PLAN COMMISSION STAFF REPORT

Agenda Item: PC Docket No. 23-018

Application: **Development Plan Review**

Summary: Maple Leaf Crossing LLC requesting approval of a Development Plan for a retail building at Maple Leaf Crossing Lot 5, located at 9470 Calumet Avenue

NOVA PROJECT NO:	MES018
COPYRIGHT	NOVA ENGINEERING, PC 2021
SHEET TITLE	ELECTRICAL SITE PLAN
DATE	05-22-2023
REVISIONS	07-01-2021 FOR BID AND PERMIT
DESCRIPTION

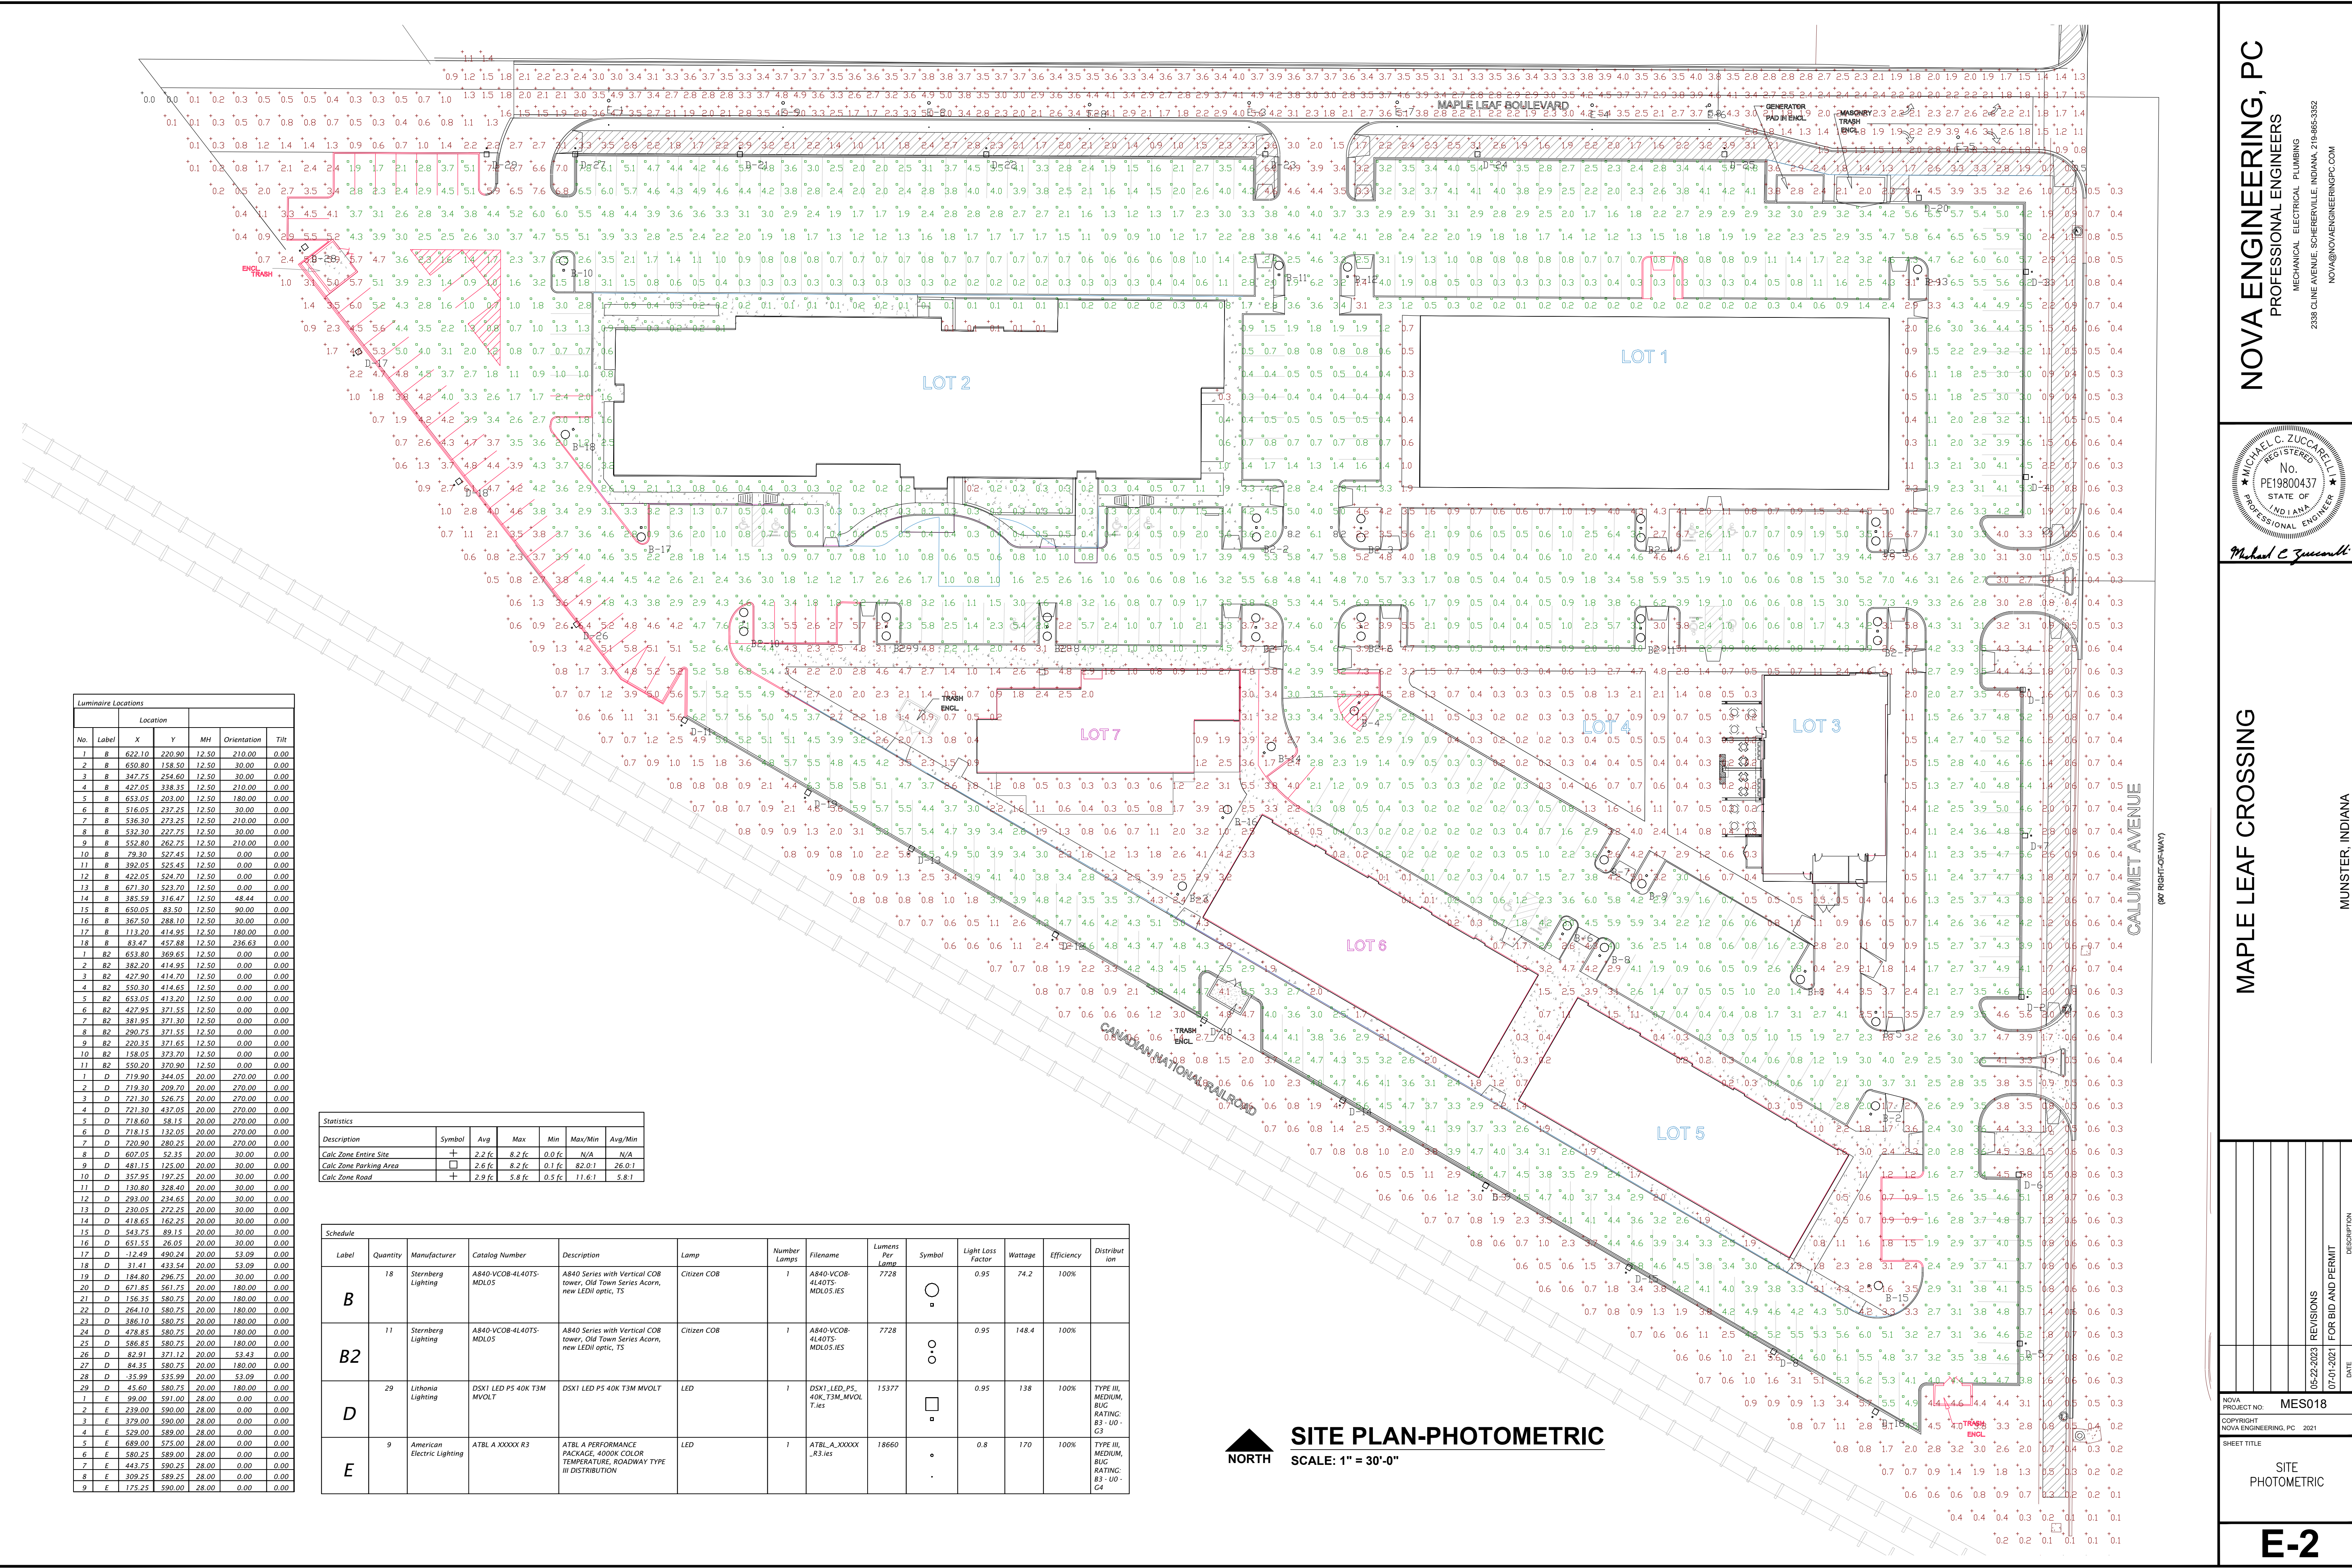
Code/Ordinance	Section	Standard	Issue
Ord. 1803	I.B.5.	Screening of Mechanicals All mechanical equipment will be screened as to not be visible by those at street level on all sides of the building.	The electrical equipment to the rear (southeast) of the structure is not screened.
	III.9.	Lighting Lighting fixtures shall be high quality commercial grade. The fixtures shall be constructed and installed to be glare free and shall comply with all applicable code requirements	A lighting plan has been submitted for both the site and the structure, however, specifications for the light fixtures themselves have not been submitted.

Additionally, the lighting plan for the overall site that was submitted does not reflect the recent revisions to the Maple Leaf PUD Development Plan that was approved by the Town Council on July 17th, 2023.

specifications for the light fixtures for the structure and the site shall be submitted to staff to ensure they are meeting the intent of the Maple Leaf PUD Developmental Standards. Lastly, the lighting plan for the overall site will be updated to reflect the most recent revisions to the site that were approved on July 17th, 2023.

- 1. The petitioner will submit a plan satisfactory to staff that shows how the mechanical equipment at the rear of the structure (southwest elevation) will be screened from public view.*
- 2. The petitioner will submit high quality commercial grade light fixture specifications for the structure and the site that are satisfactory to staff.*
- 3. The petitioner will submit an updated lighting plan that reflects the site plan that was approved by the Town Council on July 17th, 2023.*
